**Accessibility Review**

# Community Center
## City of Shakopee

Survey By JQP, MQP
Survey Date 07/14/2025

**Photo 3:** The service for the fitness coordinator is currently at 42" (vs. 36" maximum); there is not an accessible section of desk available.

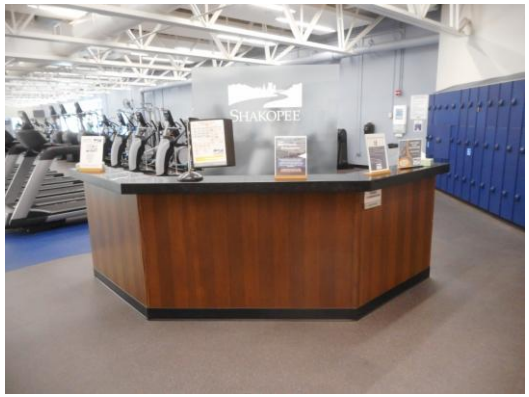
| Location / JQP # / Item # | | Solution / Comments | Qty | Unit Cost | Total Cost | Priority | Estimated Compl. Date | Person Responsible | Actual Compl. Date | Actual Cost |
|---|---|---|---|---|---|---|---|---|---|---|
| **21A** | *28573* | Lower a minimum 36" wide section of counter to a maximum height of 36" above the floor.<br>ICC ANSI 904.3<br>*Currently at 42". Photo 3.* | 1 | $1,000 | $1,000 | 3 | | | | |

**Photo 8:** The sauna provides a turning space within the room; the bench does not currently provide a clear floor space adjacent to the short end.

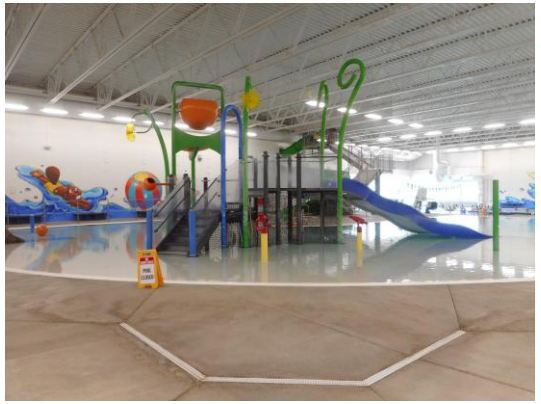
| Location<br>JQP # / Item # | | Solution / Comments | Qty | Unit Cost | Total Cost | Priority | Estimated Compl. Date | Person Responsible | Actual Compl. Date | Actual Cost |
|---|---|---|---|---|---|---|---|---|---|---|
| **68B** | *28643* | In the sauna, modify the bench to provide a clear floor space at the end of the bench and parallel to the bench.<br>MN1341 903.2<br>*The bench currently provides a clear floor space parallel to the bench but not at the short end of the bench. Photo 8.* | 1 | $500 | $500 | 3 | | | | |

**Photo 20:** The women's toilet room in the entry vestibule currently provides an ambulatory accessible toilet compartment. *This is a good example of accessibility.* The baby changing table currently obstructs the maneuvering clearance on the pull side of the ambulatory door.

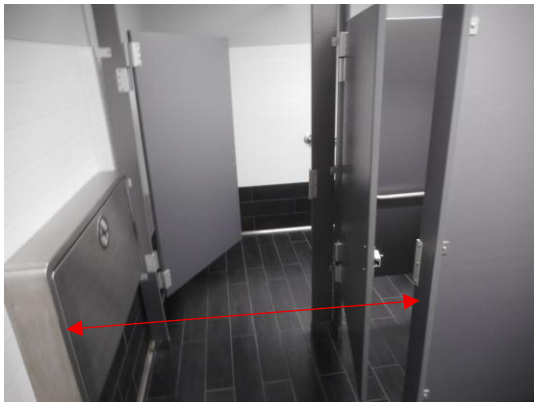
| Location / JQP # / Item # | Solution / Comments | Qty | Unit Cost | Total Cost | Priority | Estimated Compl. Date | Person Responsible | Actual Compl. Date | Actual Cost |
|---|---|---|---|---|---|---|---|---|---|
| *28613* | *The depth on the pull side of the ambulatory accessible toilet compartment is reduced to 40" (vs. 42" minimum) due to the baby changing table. Consider removal of the baby changing table. ANSI 604.10.3 Photo 20.* | 1 | $50 | $50 | 4 | | | | |

**Photo 21:** The locker rooms currently provide an accessible transfer shower. *This is a good example of accessibility.* The shower does not currently provide a hand-held spray wand.

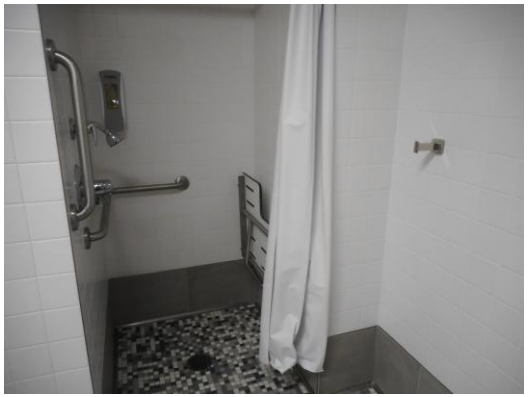
| Location / JQP # / Item # | | Solution / Comments | Qty | Unit Cost | Total Cost | Priority | Estimated Compl. Date | Person Responsible | Actual Compl. Date | Actual Cost |
|---|---|---|---|---|---|---|---|---|---|---|
| **24E** | *28694* | Provide a compliant hand-held shower wand.<br>ICC / ANSI 608.5, 608.6 | 1 | $500 | $500 | 3 | | | | |

| Location / JQP # / Item # | | Solution / Comments | Qty | Unit Cost | Total Cost | Priority | Estimated Compl. Date | Person Responsible | Actual Compl. Date | Actual Cost |
|---|---|---|---|---|---|---|---|---|---|---|
| **24E** | *28693* | Provide a compliant hand-held shower wand.<br>ICC / ANSI 608.5, 608.6<br>*Photo 21.* | 1 | $500 | $500 | 3 | | | | |

Community Center - Upper Level

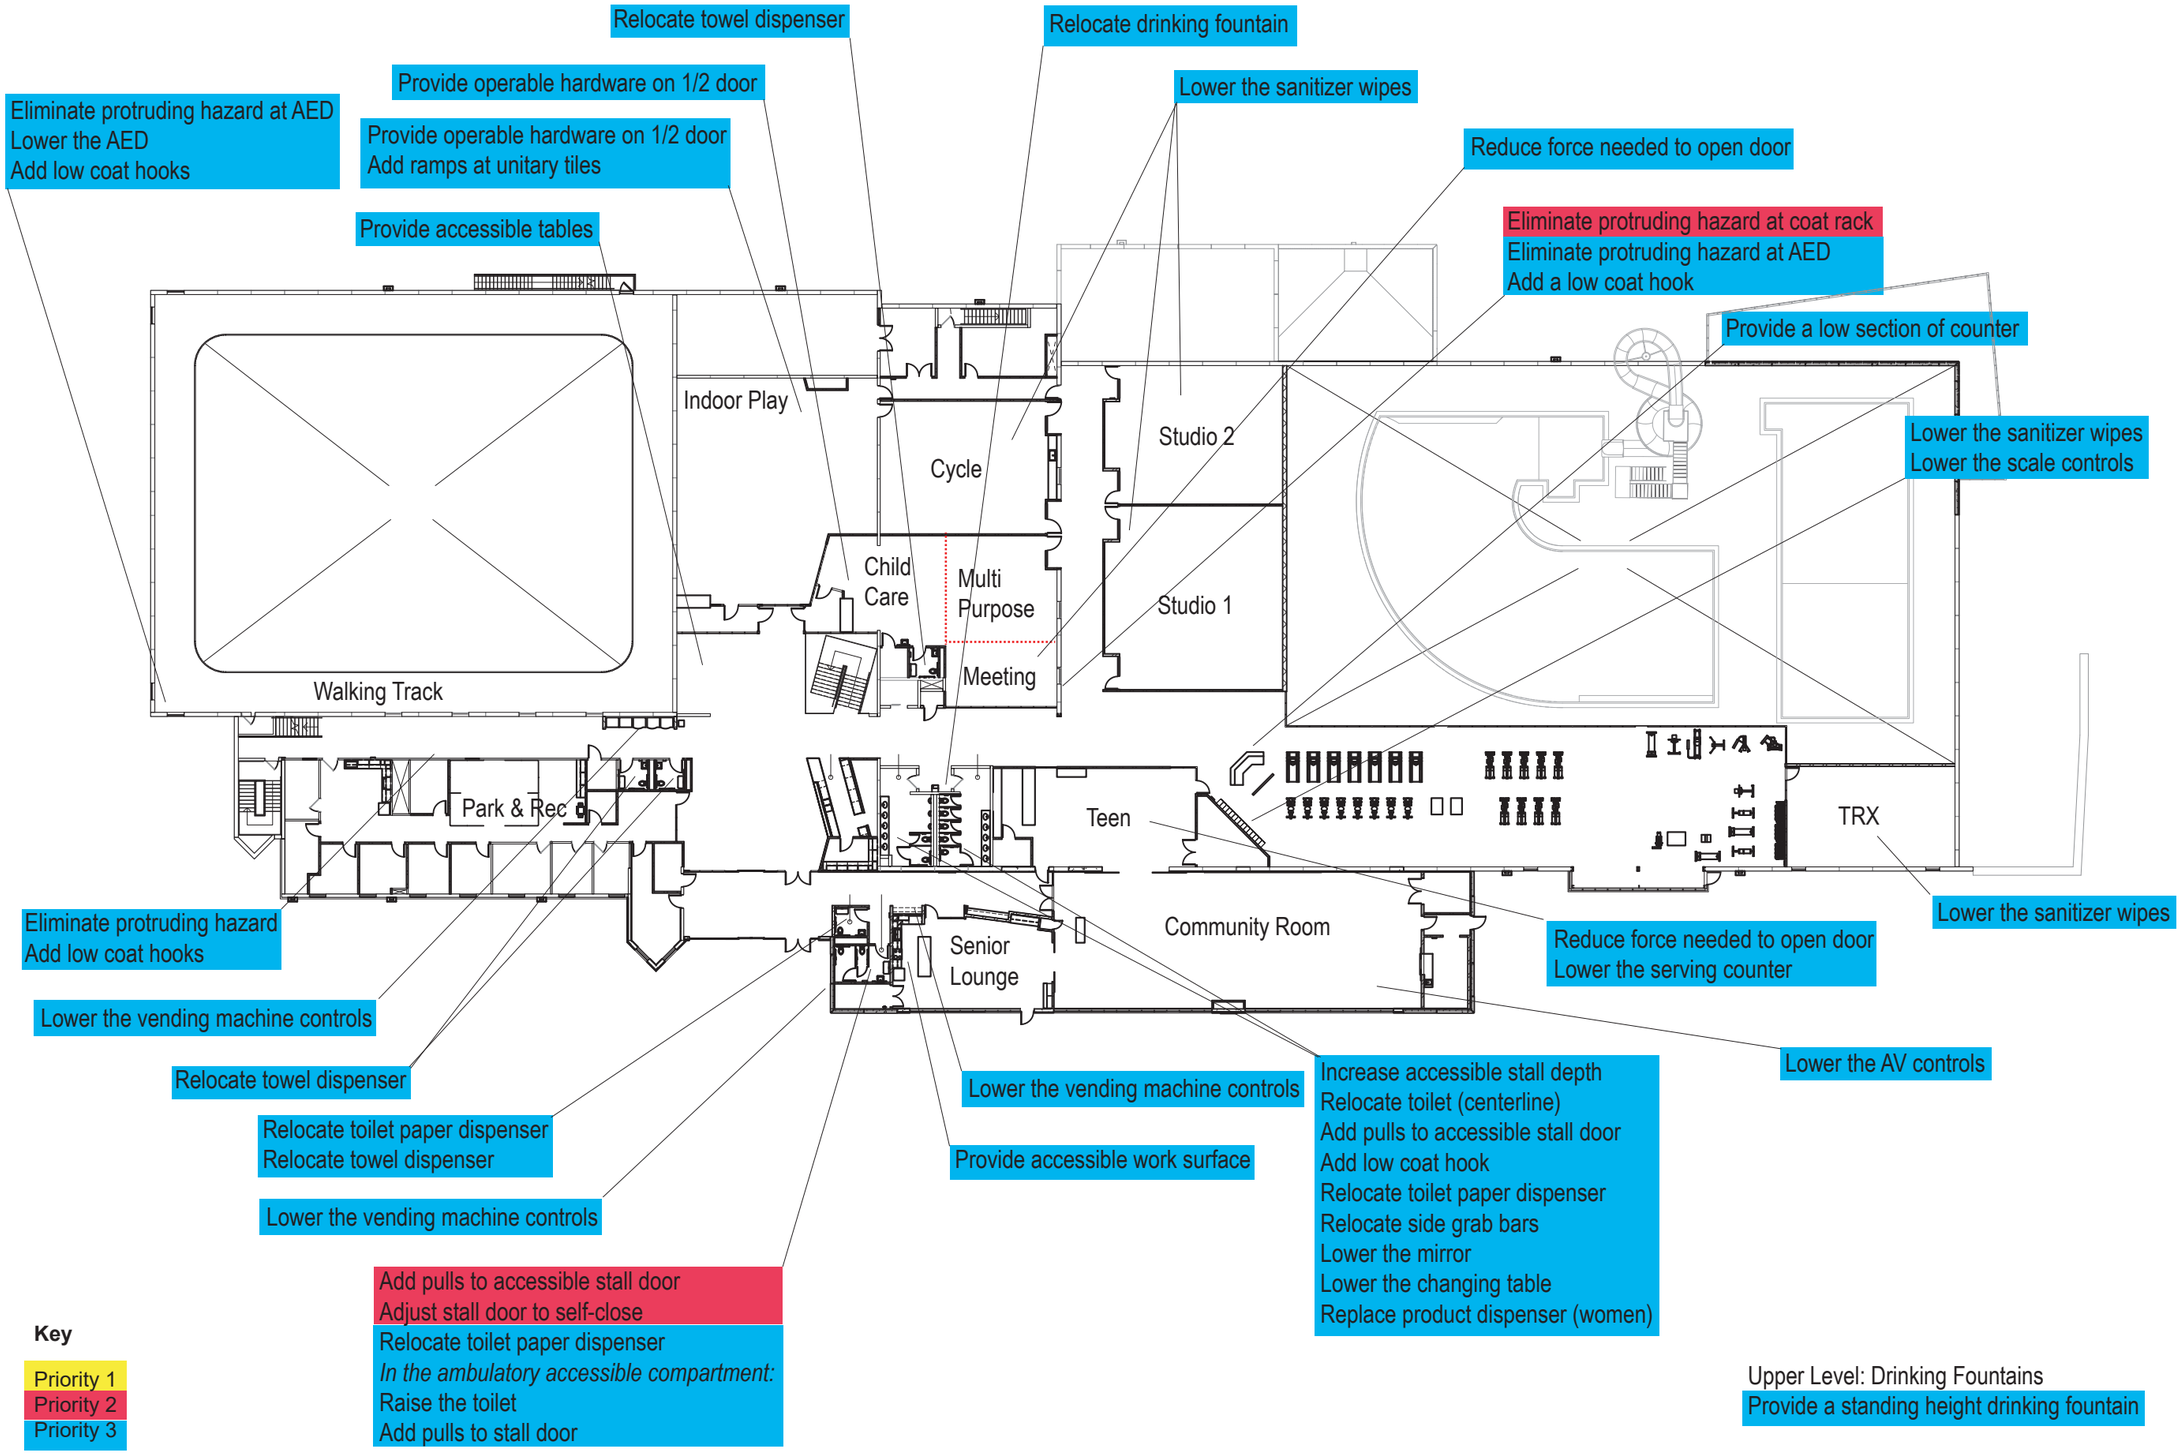
Adjust stall door to self close
Add pulls to accessible stall door

Relocate toilet paper dispenser
Eliminate protruding hazard at dryers
Reduce force needed to open entry door
Replace the product dispenser (Women)
In the ambulatory accessible compartment:
Lower the hook
Add pulls to stall door
Widen the entry door

Relocate towel dispenser
Add a low hook

Reduce force needed to open door
Replace the product dispenser

Provide easily operable hardware
to emergency communication

Lower the spa control

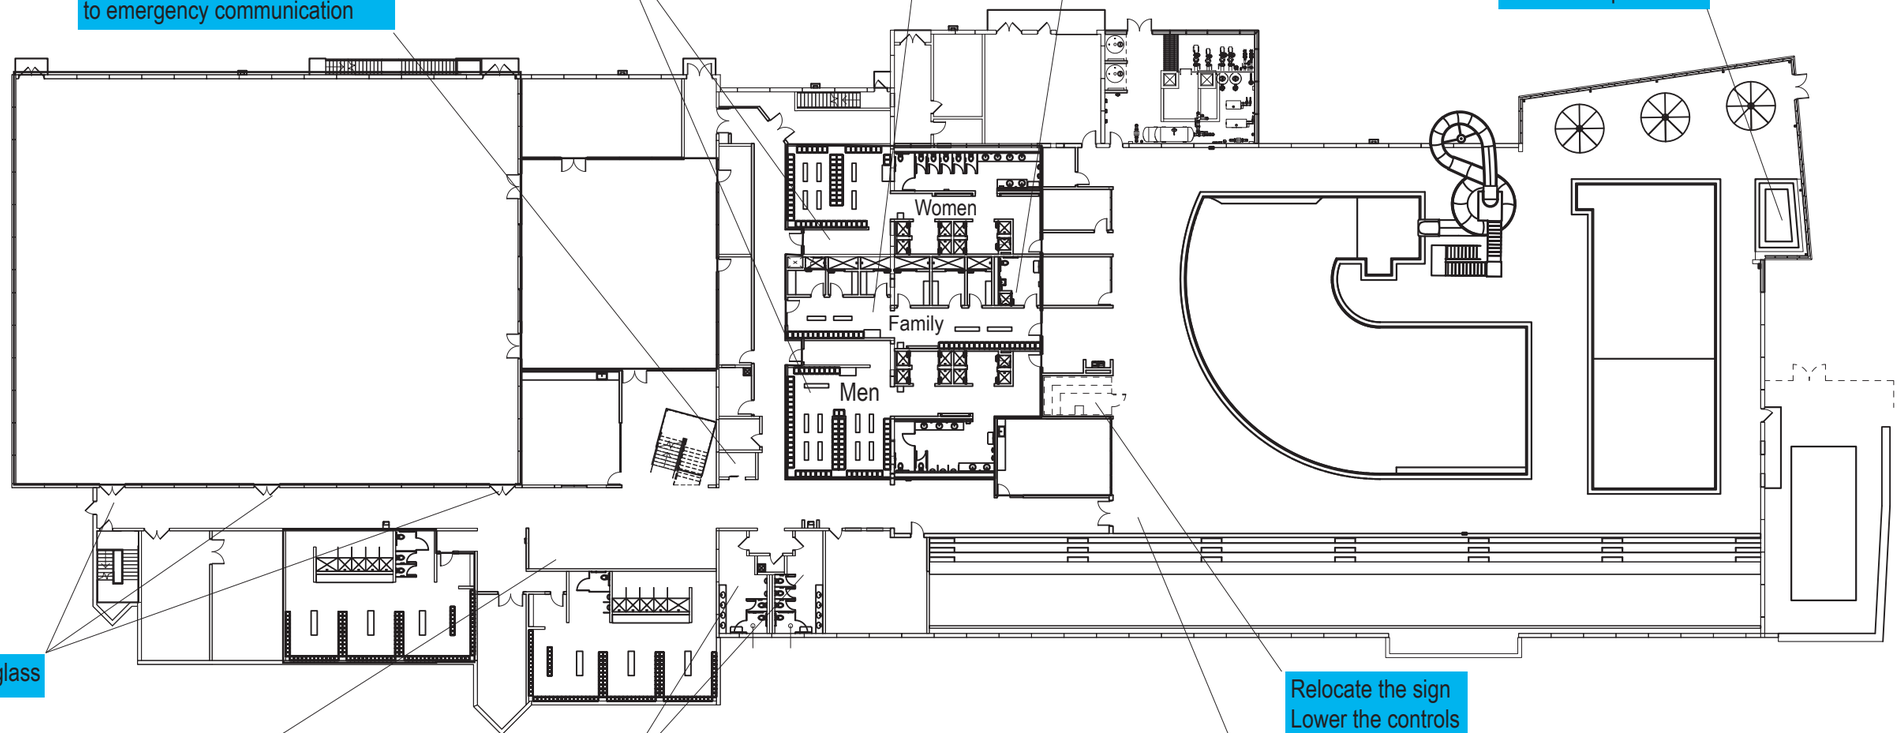
Lower the view glass

Lower the vending machine controls
Lower the AED

Increase accessible stall depth
Relocate toilet (centerline)
Add pulls to accessible stall door
Add low coat hook
Relocate toilet paper dispenser
Relocate side grab bars
Replace product dispenser (women)
